February 2, 2022

**Re: The Aurora Highlands - E 32nd Ave & TAH Pkwy ISPs (#1591421)/Pre-Application Meeting held
December 2, 2021**

STEP ONE: PLANNING PHASE

1G. *Implementation*

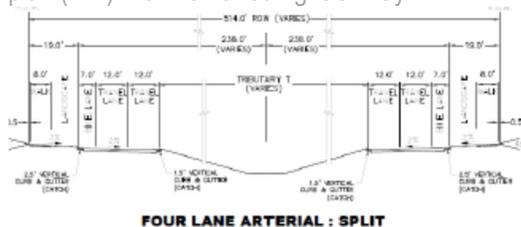
Please identify on the plans the responsible party for each component of the project, including but not limited to, lighting, sidewalks, and landscaping. If phased, please identify each phase.

Response: The consultants have been listed on the Cover Sheet.
